Subject: General Atomic Company Organization  
Change Notification

In accordance with Paragraph 4 of the referenced letter, notification is provided of a change in General Atomic Company's organization as depicted in Figure 17-2 of Amendment 5 of General Atomic's Quality Assurance Topical Report, GA A13010A, as amended on February 20, 1980.

FIG. 17-2 QUALITY ASSURANCE ORGANIZATION

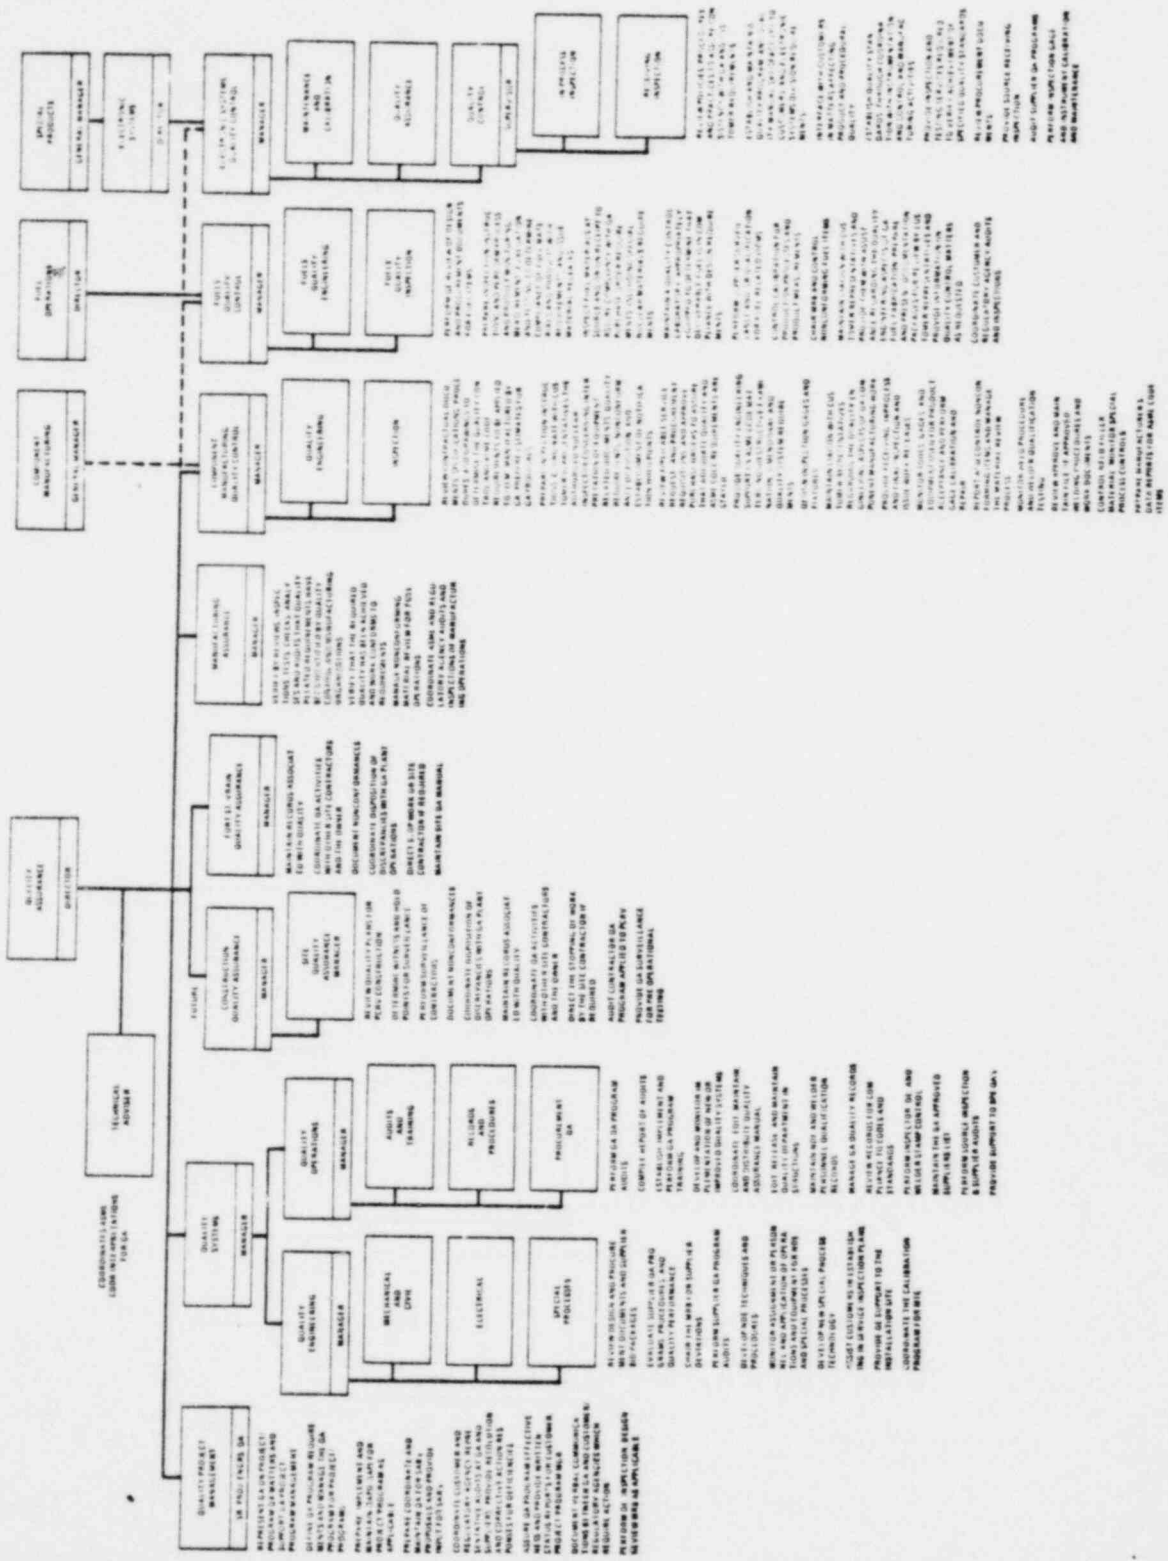
The changes in Figure 17-2, titled Quality Assurance Organization, are in the names of the Fuel Operations Quality Control operations with functional and reporting responsibilities remaining essentially unchanged. The specific changes are Fuel Manufacturing Quality Control is renamed Fuels Quality Control, Quality Engineering is retitled Fuels Quality Engineering, and Quality Control Laboratory and Inspection is renamed Fuels Quality Inspection.

I have included a revised Figure 17-2 which replaces the copy transmitted on February 20, 1980 and will be incorporated in Amendment 6 of GA's Topical Report.
